Planning Application referral to City Design

To be filled in by Planner	
Application number:	PDPL/01407/2021
Address:	223 Rouse Street, Port Melbourne
Applicant:	Song Bowden Planning
Planner:	Martin Cooksley
Date of Referral:	2 June 2022
Date to be completed	Click or tap to enter a date.
TRIM References:	Click or tap here to enter text.
Referral Type	Urban Design
Overlays	DCPO1, DDO1-2, EAO
Contributory Heritage Place (outside HO)	No
Planning Zone	Mixed Use Zone
Proposal Summary	The construction of a six-storey mixed use development with rooftop deck and basement car stacker, containing 8 dwellings and an indoor recreation facility at ground floor; a reduction in the car parking requirements; and the removal of restrictive covenant on title.;;
Relevant documents	See docs in Advertised Plans section of Attachments in One Council file.
Specific information sought by the planner	Follow up referral after initial referral – applicant addressed some concerns from RFI, also provided an urban design response. Please identify any outstanding or new issues.

To	Martin Cooksley, Senior Urban Planner
From	Lingna Zhang, Senior Strategic Planner
Date	June 2022
Subject	223 Rouse Street, Port Mel

- Reduce the size of front balconies on level 4-6 by 3 sqm each and substitution rhs balustrades for concrete wall on the sides- an improved presentation to the street frontage (Left – amended; Right – original)

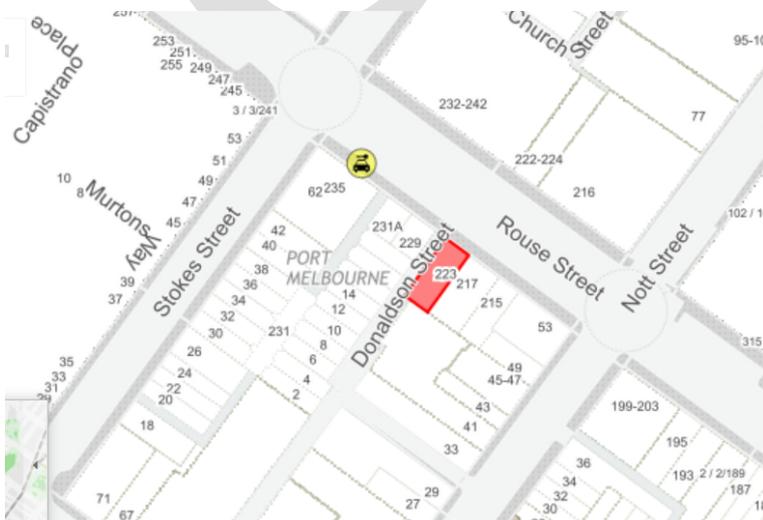
The front setback of Level 4-6 should be further increased to better respond to the lot size, the DDO1-2 built form requirement within 5m of street, and outcomes especially in relate to its interface with the low scale and residential neighbourhood:

- The amended proposal made minor change to the front setback. With a front setback of 3 m, the amended proposal still represents a significant departure from the '10.5 preferred maximum height less than 5 metres from any road boundary'.

- The Cantilevered front balconies on level 4-6, while each reduced by 3 square metres in size, still project 2.1m into the front setback with significant visual weight. Strategic planning suggests the applicant to consider reduce the size of balconies, and/or substitute clear glass (similar to balcony 1) for rhs balustrades to reduce the visual weight.

- The applicant should also consider further reduce the size of the balconies of level 4-6 and/or use framed clear glass balustrade (similar to balcony 1) to reduce visual impact projected into the setback.
